161 Alden Road, Units 7 & 8, Markham, Ontario Canada L3R 3W7 Tel: +1 416 754-3322 Fax: +1 416-754-3299 Email: support@edac.net http://www.edac.net	
ENGINEERING CHANGE NOTICE			
Originator:	Mit Patel	Date:	Document Number
Phone No.	416-754-3322	May 26, 2025	20250526-00
Email Address:	mpatel@edac.net		
Department	Quality	Revision Number	SHEET
		1	1 of 2

Drawing correction

DRAWN BY		J.S.M		PIN HEADER, 2.54MM PITCH, 1X10P, R/A DIP							
		DRAWN DATE		2024/08/26									
		CHECKED BY		J.L		PART NUMBER		151-610-416-961					
		CHECK DATE		2025/06/10									
RoHS COMPLIANT	THESE DRAWINGS AND SPECIFICATIONS ARE THE PROPERTY OF EDAC, AND SHALL NOT BE REPRODUCED , OR COPIED OR USED AS THE BASIS FOR THE MANUFACTURE OR SALE OF APPARATUS WITHOUT WRITTEN PERMISSION	TOLERANCES		ALL DIMENSIONS AND TOLERANCES IN MM		MATERIAL		PA6T		SIZE		A	
		.X ±0.25				REF: EC3815, EC8995				REVISION			
		.XX ±0.20								R2			
		.XXX -				SCALE		1:1		SHEET		1

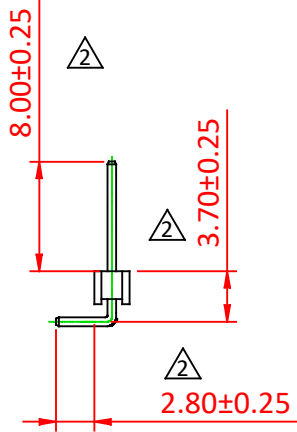
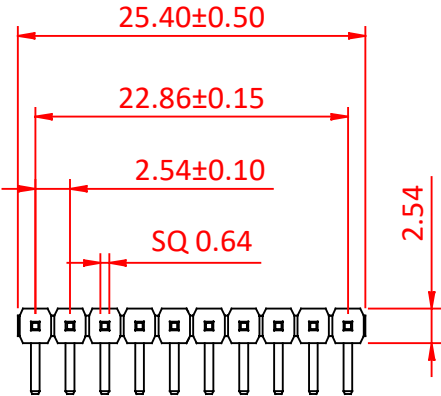
The correction has been made on 151-610-416-961. Please see the correction below. This change will not affect the part's form, fit, and function.

REVISIONS			
REV.	DESCRIPTION	DATE	BY
1	ORIGINAL	2024/08/26	J.S.M
2	2.80 WAS 3.70, 3.70 WAS 2.80, 8.00 WAS 8.80	2025/06/10	J.S.M
